DOCUMENT 00 91 13

Addendum Number Two

PROJECT: ITD D5 Maintenance Building Addition and
Renovation and New Brine Facility
Blackfoot, Idaho

PROJECT NO.: 22569

ARCH. JOB NUMBER: 22569
 CLIENT PROJ. NUMBER: --
 SHEET ISSUED DATE: FEB 2023
 SHEET: **SP100**

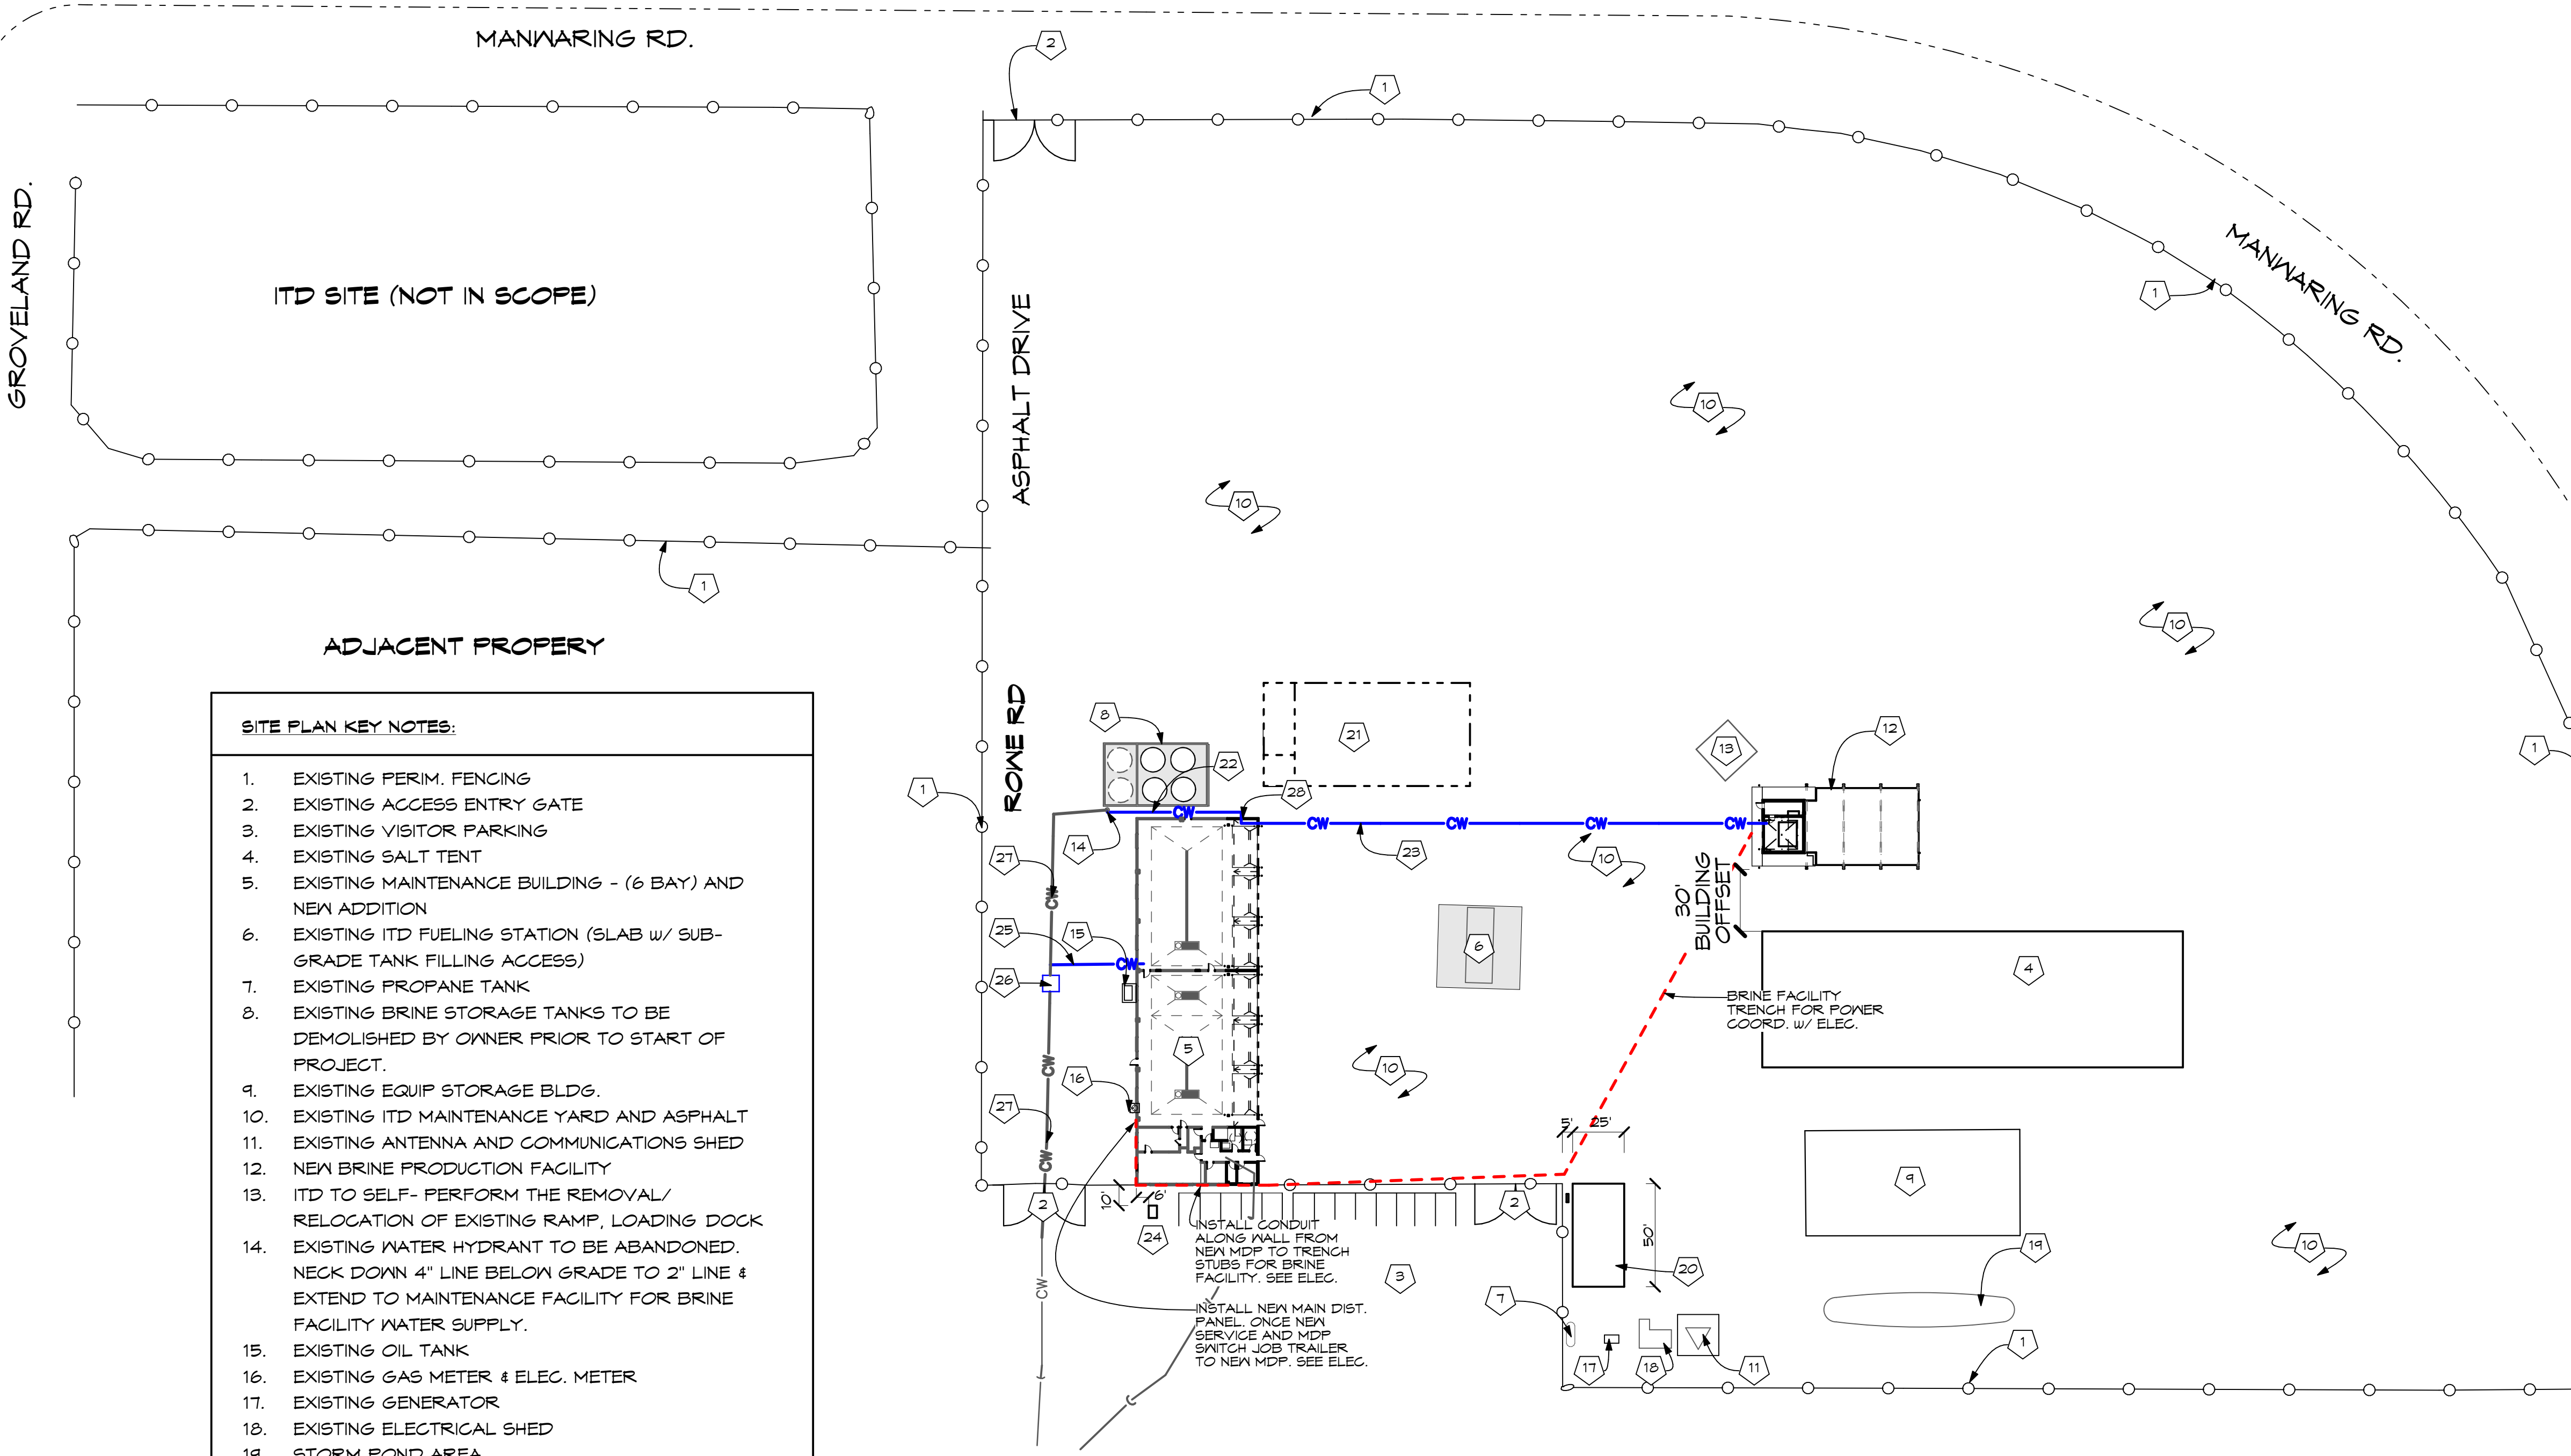
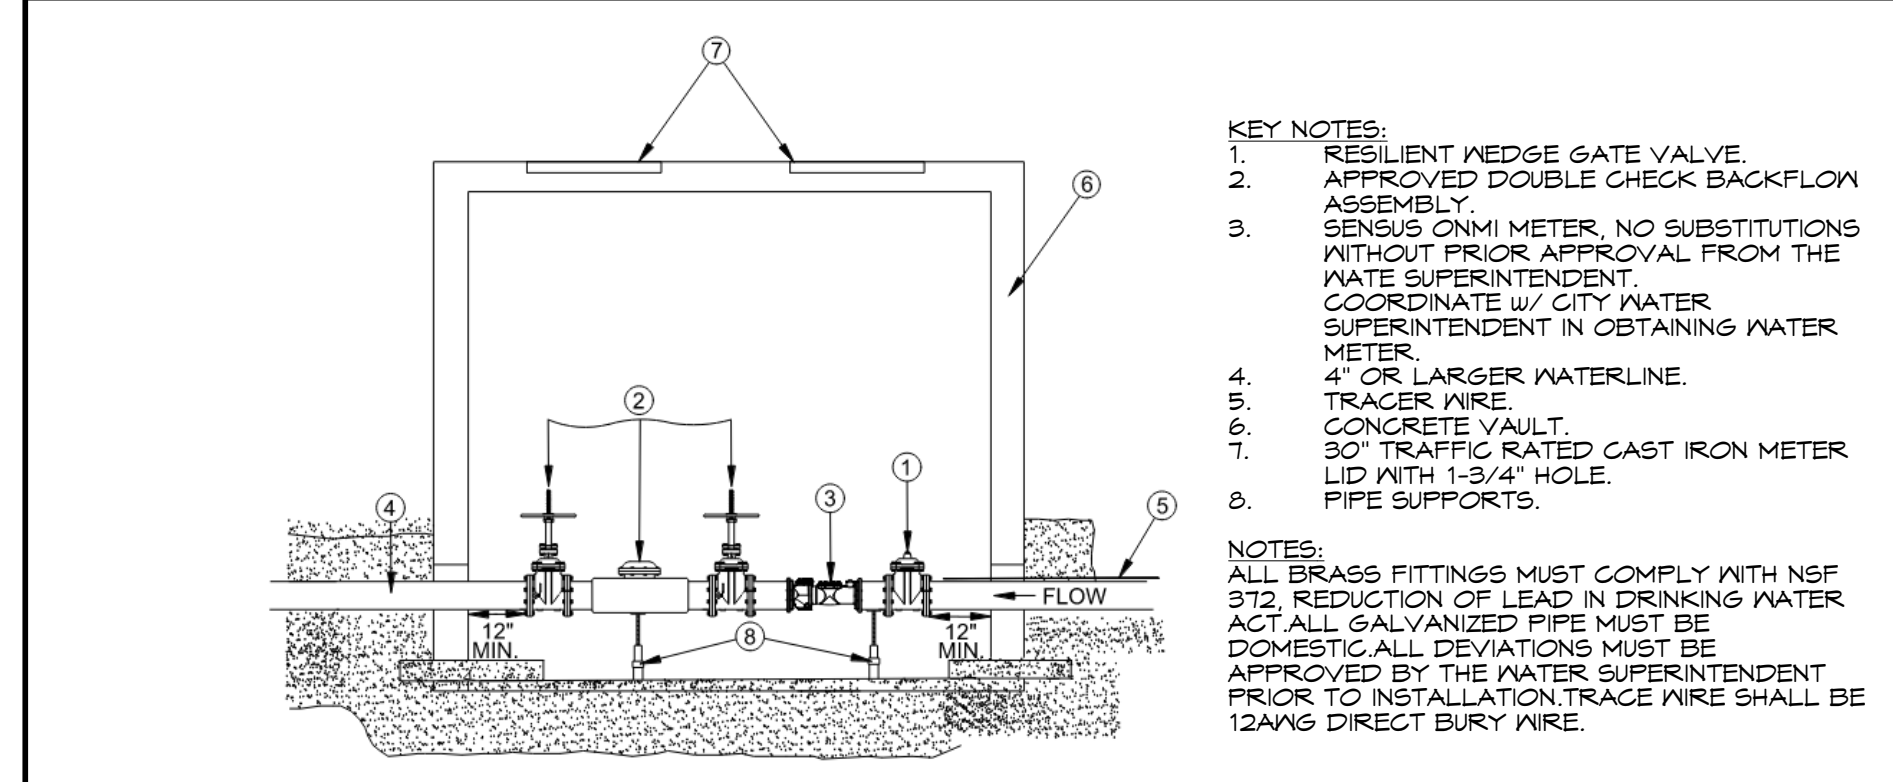
1. Replace Sheet SP100 – Architectural Site Plan with attached Sheet SP100 – Architectural Site Plan. Revisions are as follows.
 - a. Provided detail for and clarification for 4” water meter requested by the City of Blackfoot.

- b. Provided clarification on fire suppression main.
 - c. Provided information and clarification on 2” water line to Brine Production Facility.
2. Sheet D100 – Demolition Plan: Add Alt#1. Fire suppression main to tie to existing 4” water line on west side of building, coordinate with revised sheet SP100.
